**CONTRACT ADDENDUM #**

**date:** 5.10.24  
**project:** Hyde Park Middle School  
**by:** Michael Rigby  
**subject:** Addendum 02

**HPMS ADDENDUM #2**

**SUBJECT:** **Addendum #2 – Changes to Bid Package #1**

**A-113.0**

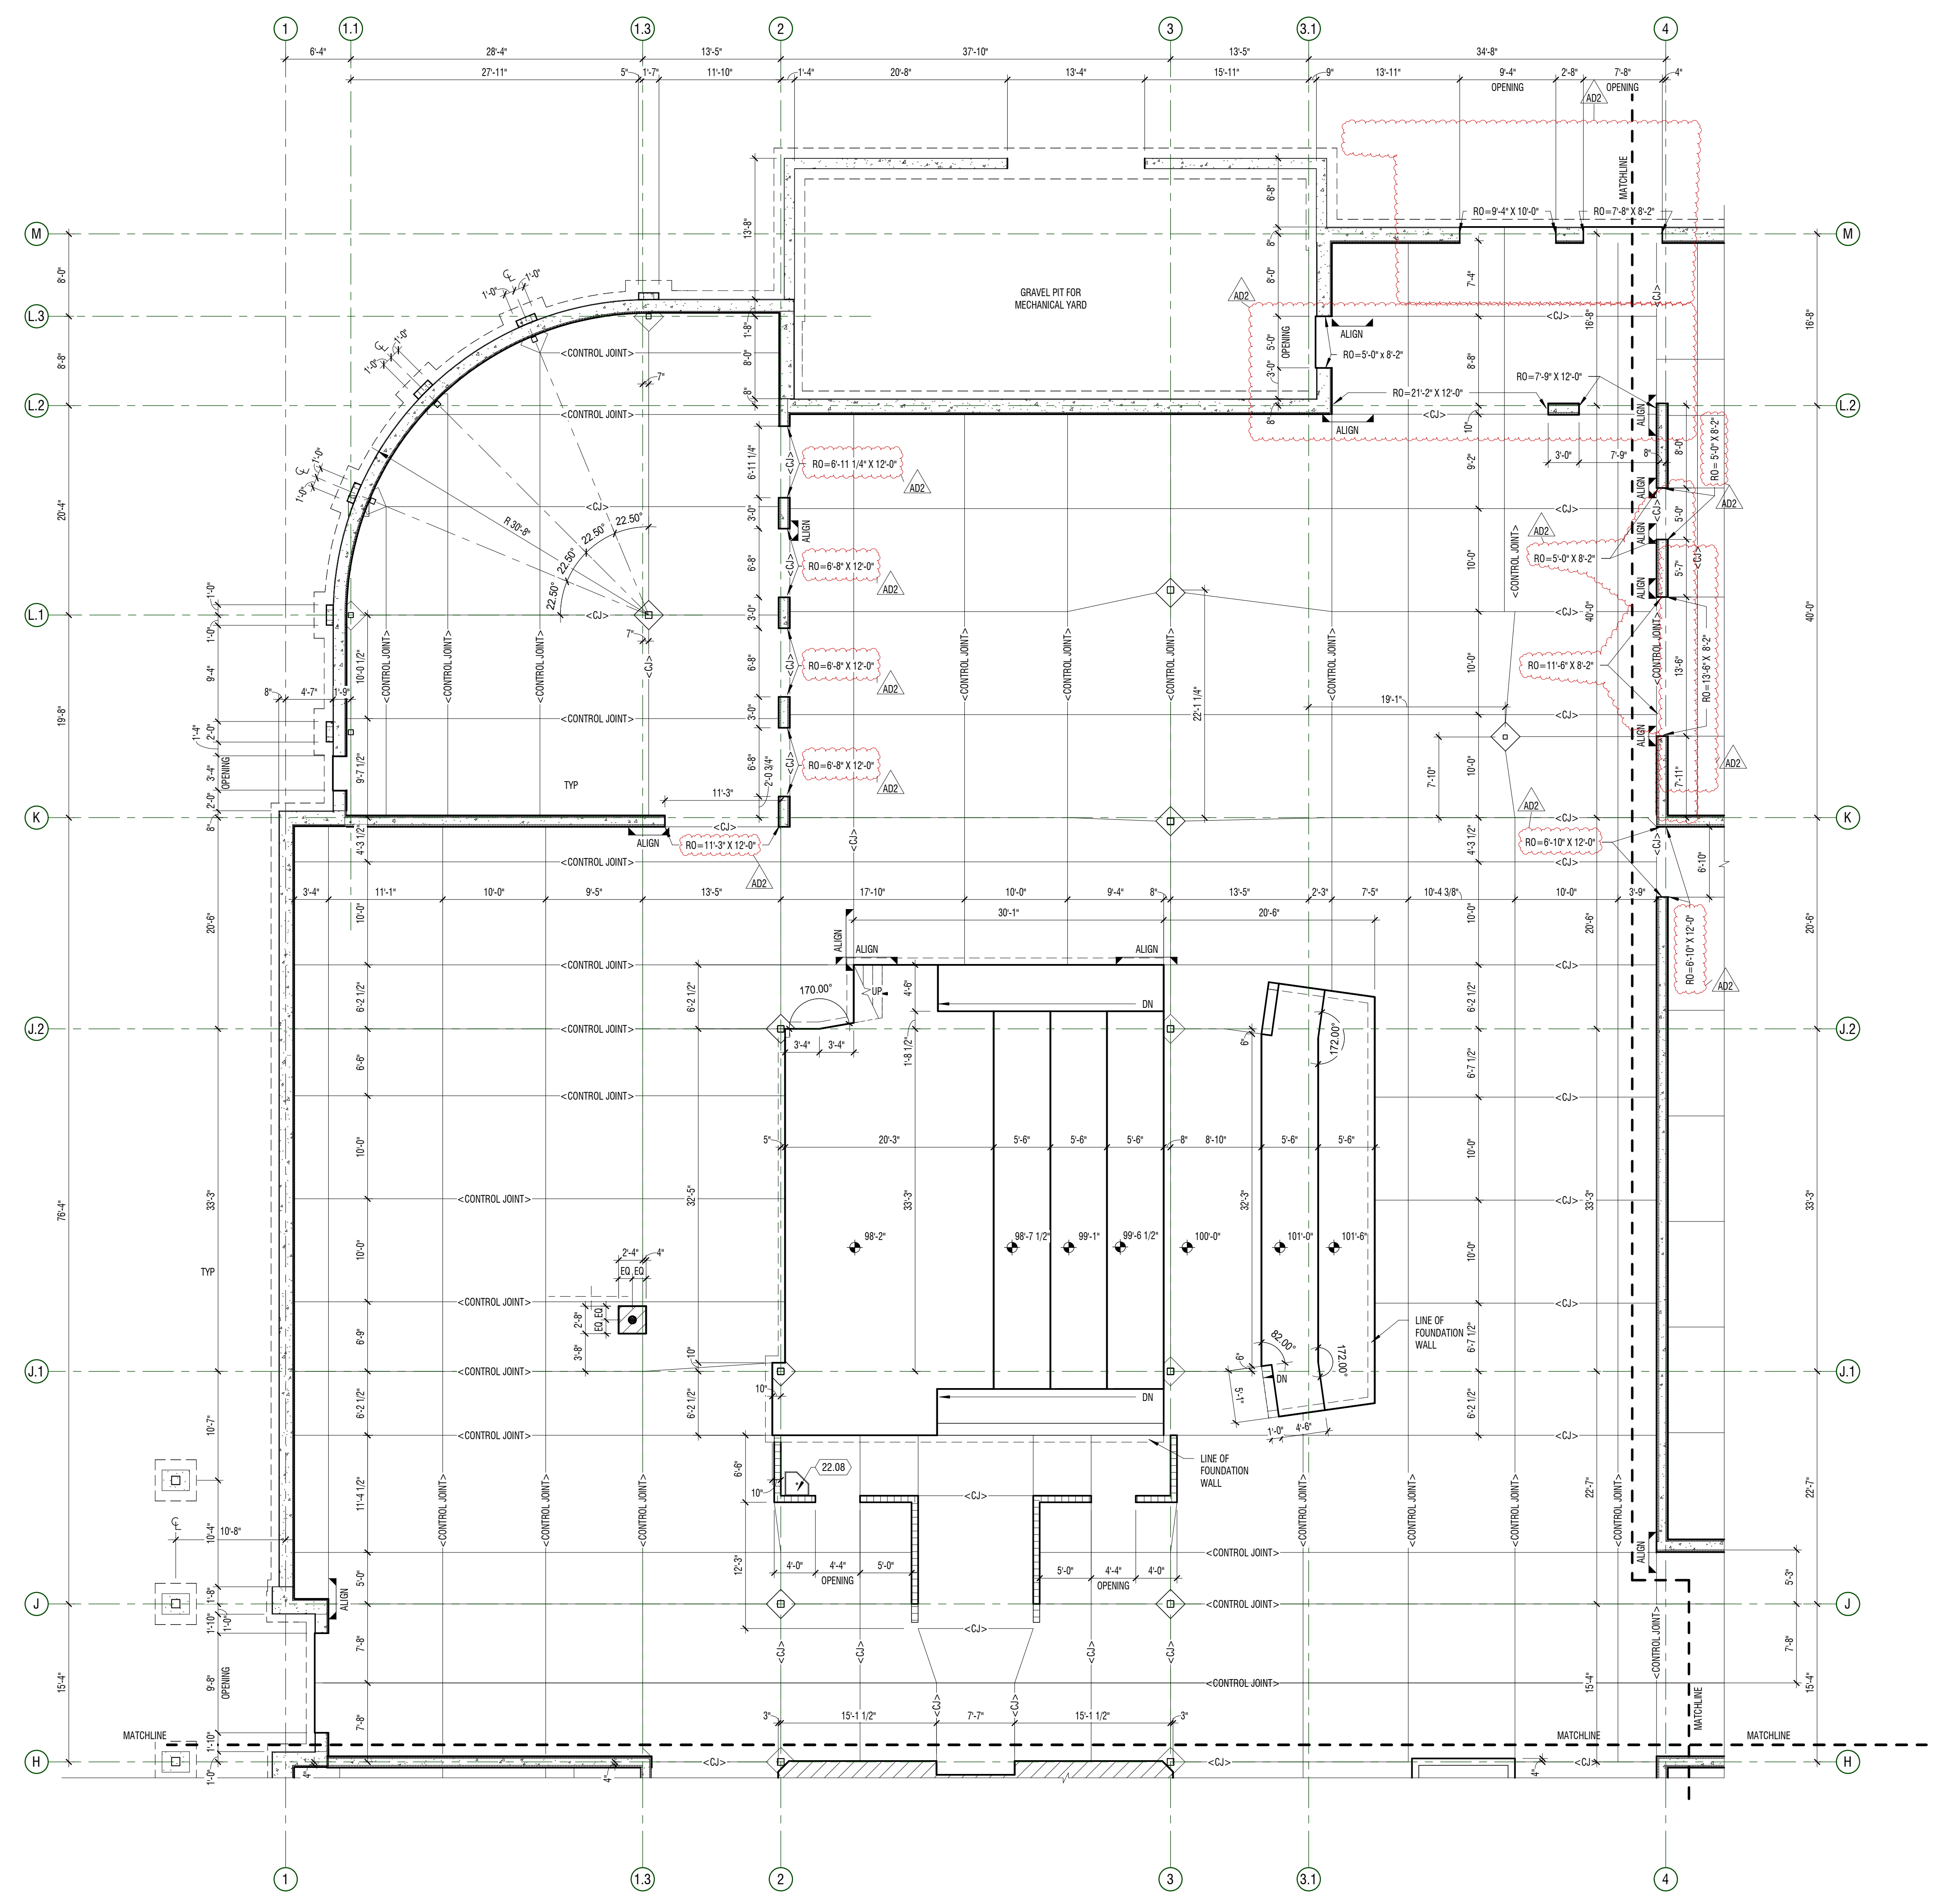
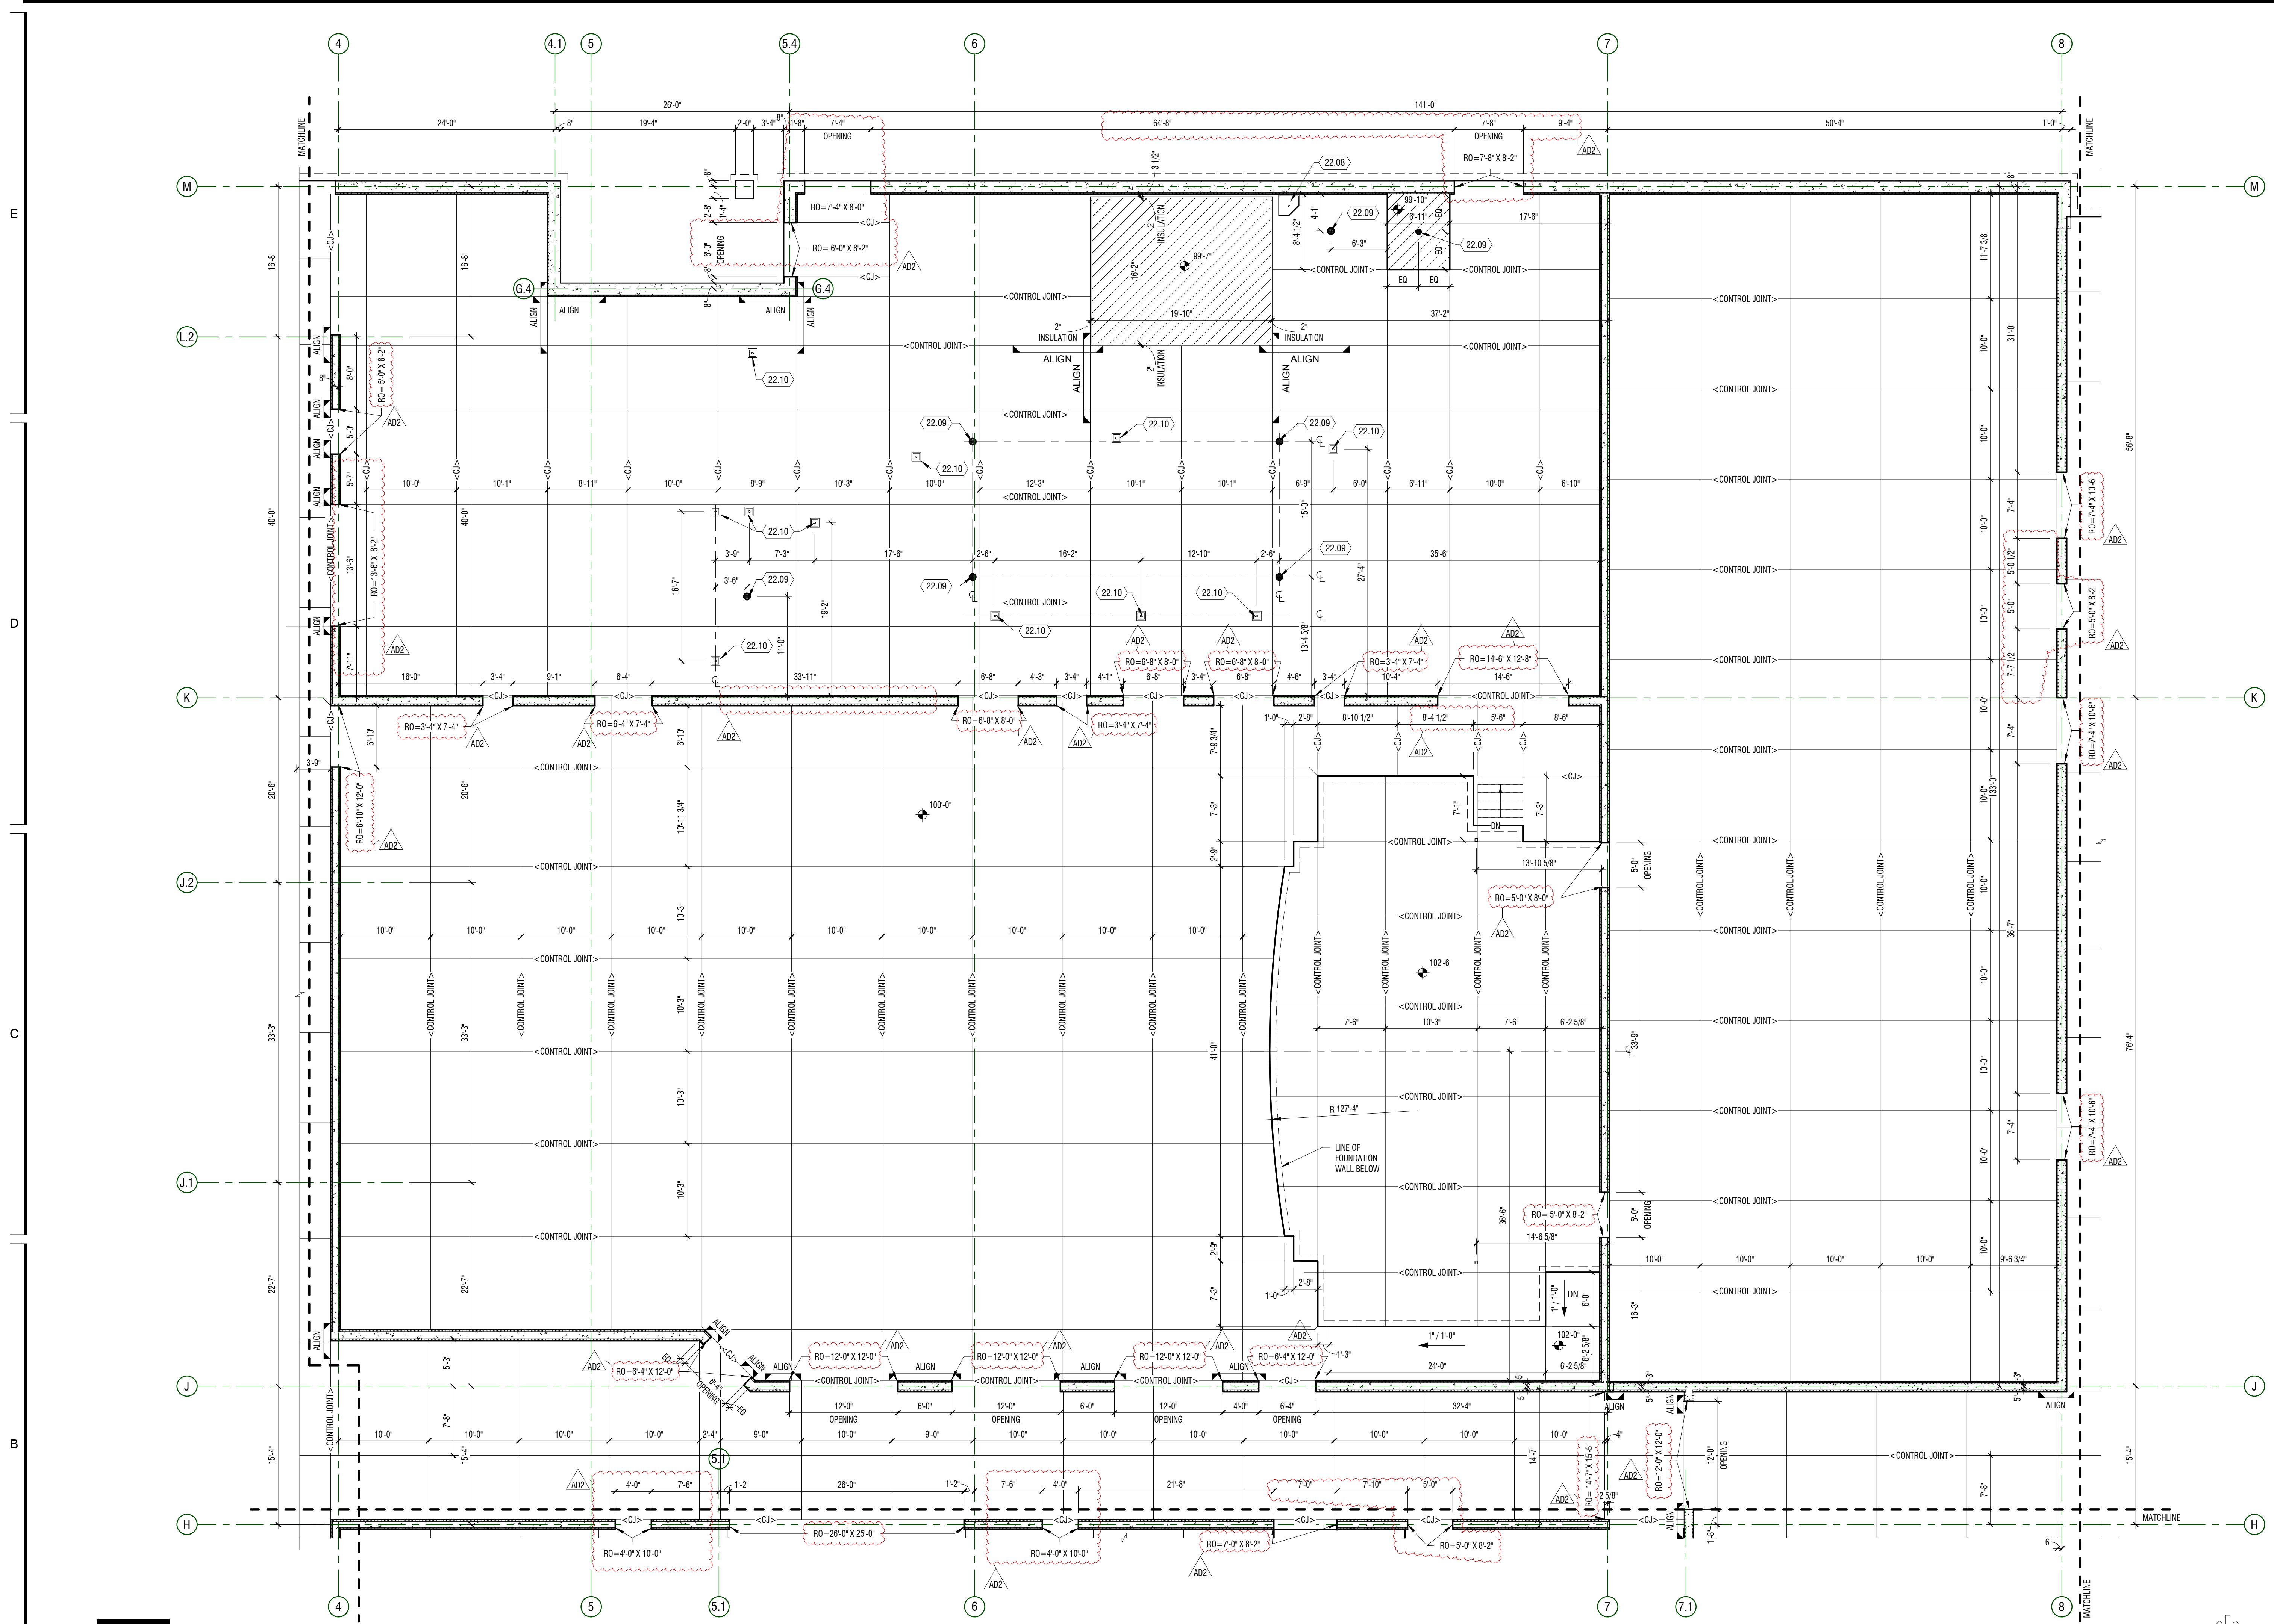
- 02.01      A-111.0 – PLAN – LEVEL 01 – AREA A – SLAB & FOUNDATION
  - ROUGH OPENING (RO) OF CONCRETE/ICF OPENING.
- 02.02      A-112.0 – PLAN – LEVEL 01 – AREA B – SLAB & FOUNDATION
  - ROUGH OPENING (RO) OF CONCRETE/ICF OPENING.
- 02.03      A-113.0 – PLAN – LEVEL 01 – AREA C – SLAB & FOUNDATION
  - ROUGH OPENING (RO) OF CONCRETE/ICF OPENING.
- 02.04      A-114.0 – PLAN – LEVEL 01 – AREA D – SLAB & FOUNDATION
  - ROUGH OPENING (RO) OF CONCRETE/ICF OPENING.
- 02.05      A-115.0 – PLAN – LEVEL 01 – AREA E – SLAB & FOUNDATION
  - ROUGH OPENING (RO) OF CONCRETE/ICF OPENING.
- 02.06      A-115.0 – PLAN – LEVEL 01 – AREA F – SLAB & FOUNDATION
  - ROUGH OPENING (RO) OF CONCRETE/ICF OPENING.
- 02.07      See attached Civil Items
- 02.08      See attached Structural Items

**SITE PLAN - SOUTHWEST**  
 SCALE: 1"=20'

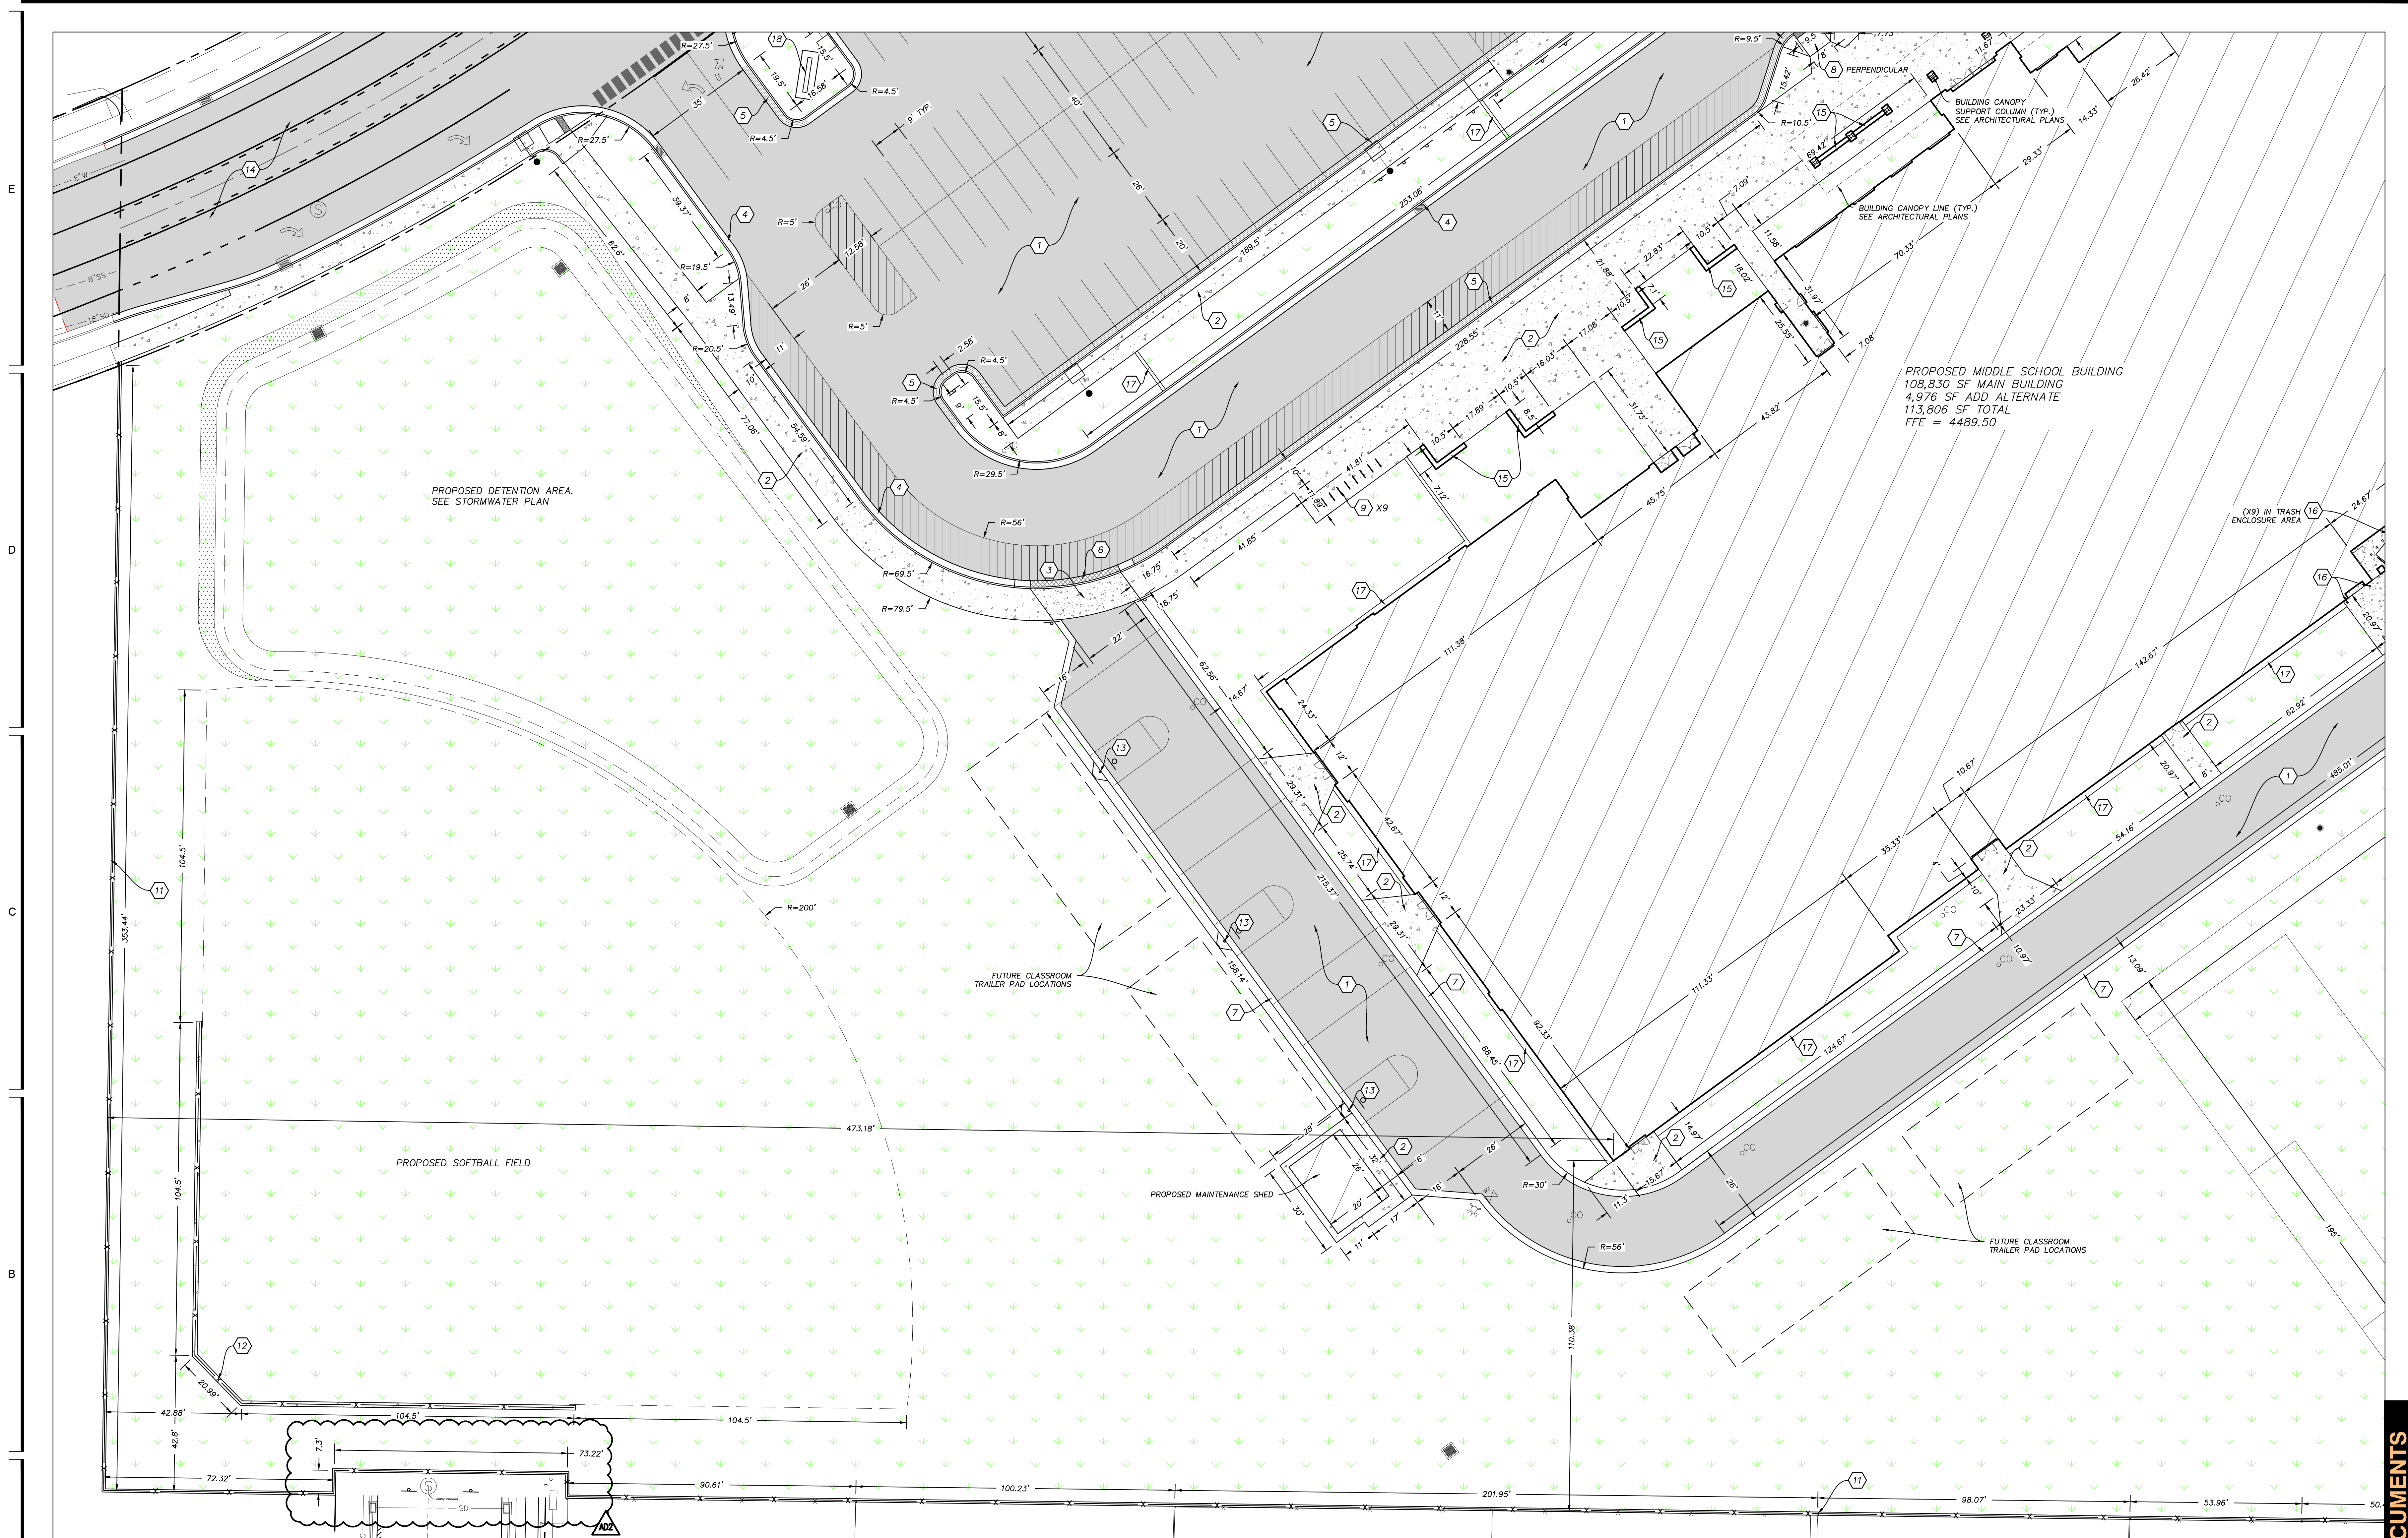
- 6. Civil – Site Plan – Southwest, Sheet C-202.**
  - a. CHANGED** – Routing of fence at end of 350 South Street to allow Hyde Park City to access existing SSMH at north end of Street.
